Title:                   Advisory Committee on Reactor Safeguards  
                              NuScale Subcommittee Open Session

Date:                  Tuesday, February 7, 2017

14 The purpose of the meeting is for the  
15 subcommittee to review NuScale's Topical Report, TR-  
16 1015-18653, Highly Integrated Protection System  
17 Platform, Revision 1.

## FPGA Equipment Diversity Allocation in a Representative Architecture

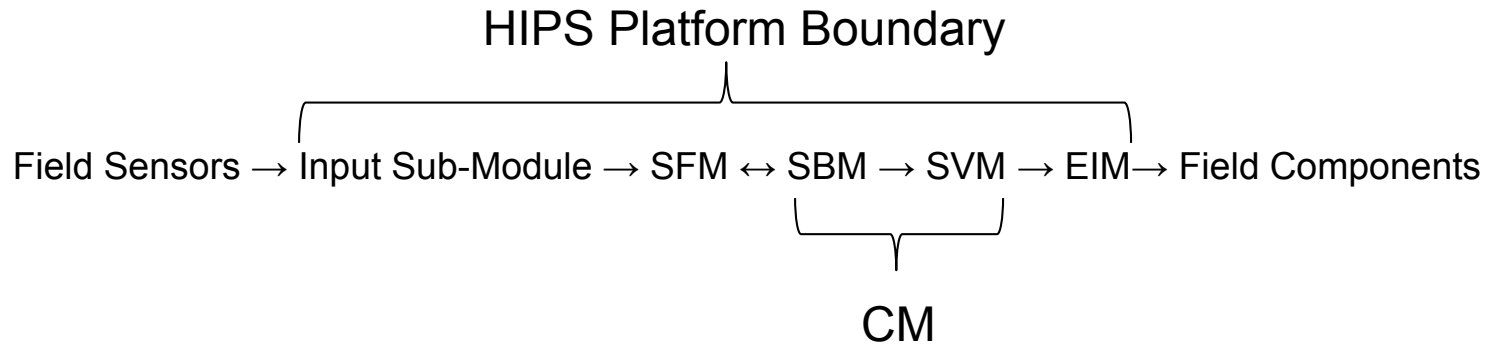
14 The example in the topical report, the  
15 four separation group, protection system is based on  
16 using one FPGA technology with two of the separation  
17 groups and a number of kind FPGA technology with the  
18 other two separation groups. This is shown as  
19 yellow and red from the figure.
